Staff Report to the Plan Commission

Fernway Park Elementary School Expansion

Project: 2024-0807 Fernway Park Elementary School Expansion

SITE PLAN

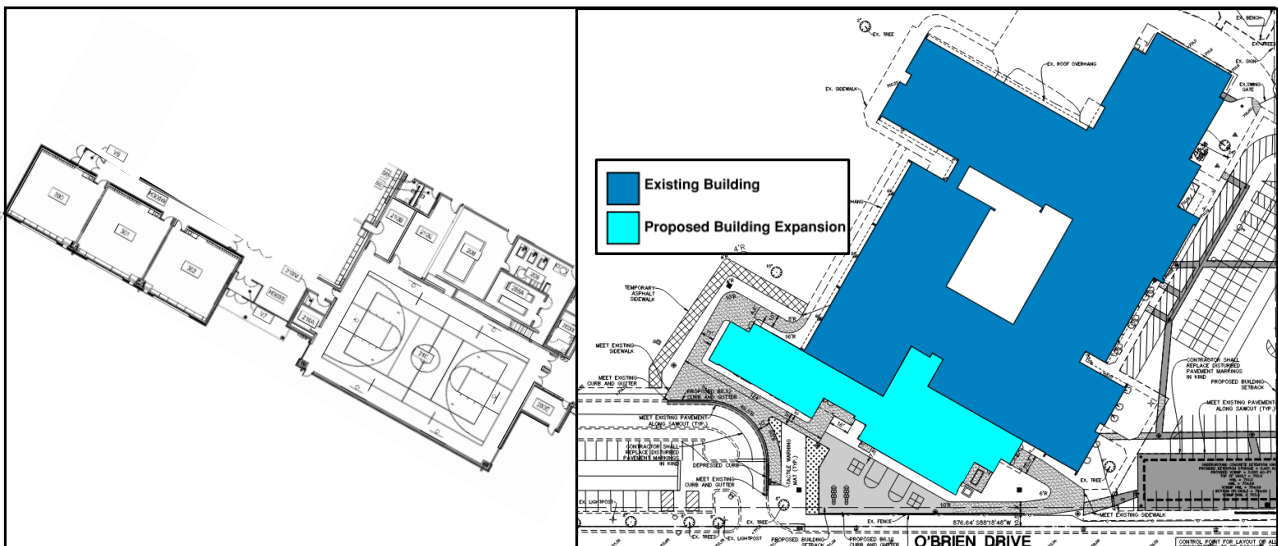
The proposed expansion extends the building south to accommodate a new gymnasium, allowing the gym and the existing lunchroom to function as separate spaces. The expansion also includes three additional classrooms, one office, and mechanical rooms. The main school building and parking areas are located along 88th Avenue, and the bus drive is accessed from O'Brien Drive. The access points will remain unchanged, except for the improvements to pedestrian and bicycle accessibility on site.

The proposed building expansion will decrease the south and rear setbacks; however, both will continue to exceed the minimum requirements of the R-2A District. No changes are proposed to the layout of the parking lot or to the north and east setbacks.

The proposed expansion of Fernway Park Elementary School will increase the overall building size and add three additional classrooms. In accordance with the LDC, 1.5 parking spaces are required per classroom. While no substantive changes to the existing parking lot are proposed, one accessible parking space will be added near the main entrance to comply with ADA requirements.

Pedestrian and Bicycle Mobility

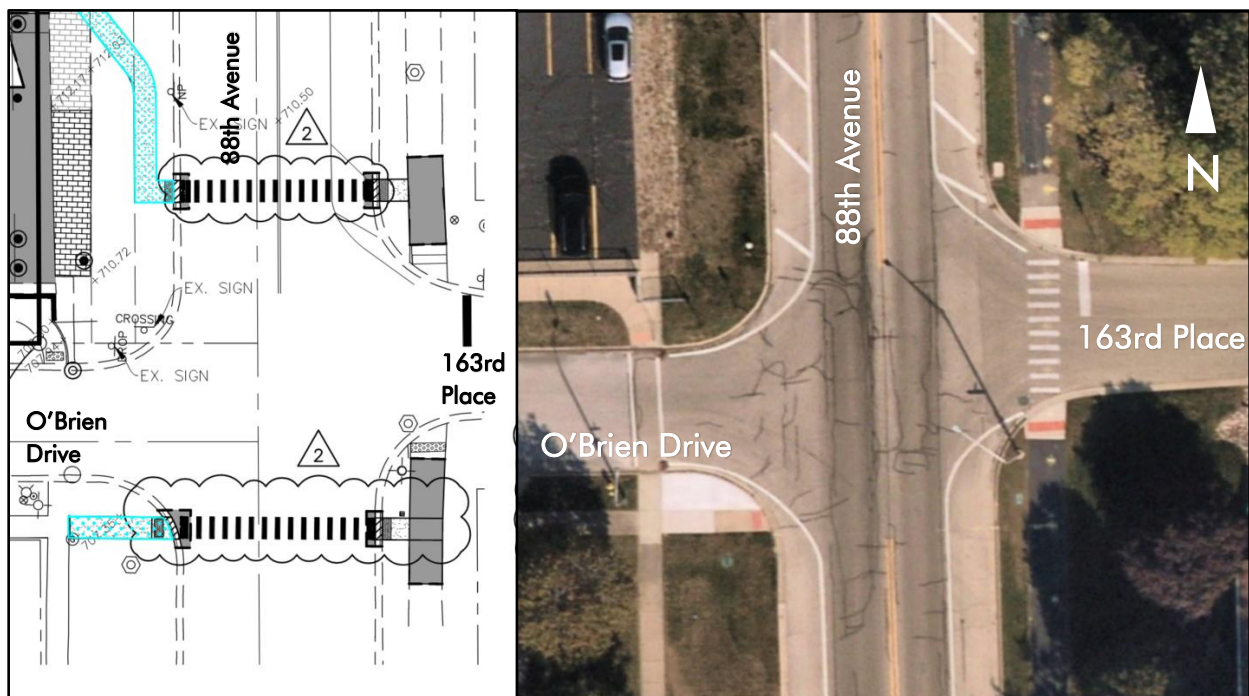
The site currently has a partial sidewalk along the southern property line near O'Brien Drive, but lacks continuous public sidewalks within the right-of-way on 88th Avenue. Staff has requested that the petitioner install the missing sidewalk along their 88th Avenue frontage. As part of the sidewalk expansion, two new crosswalks are proposed at the north and south sides of the 88th Avenue and O'Brien Drive intersection, providing a connection to the existing bicycle path on the east side of 88th Avenue. A sidewalk connection at the northwest corner of O'Brien Drive and 88th Avenue could not be provided due to existing topography, drainage conditions, and the current parking lot layout. Future site improvements should consider adding a sidewalk connection in this area.

An additional crosswalk is proposed at the intersection of 88th Avenue and 163rd Street at the north end of the school property, to provide a safer and more visible crossing point for pedestrians. As part of these improvements, the existing mid-block crosswalk near the main entrance will be removed, improving overall traffic safety. These enhancements directly support the Comprehensive Plan goal for the Fernway Planning District by promoting safer, more accessible non-motorized travel routes for students and the surrounding neighborhood. To further ensure pedestrian safety, crossing guards will continue to be present during student drop-off and pick-up hours.
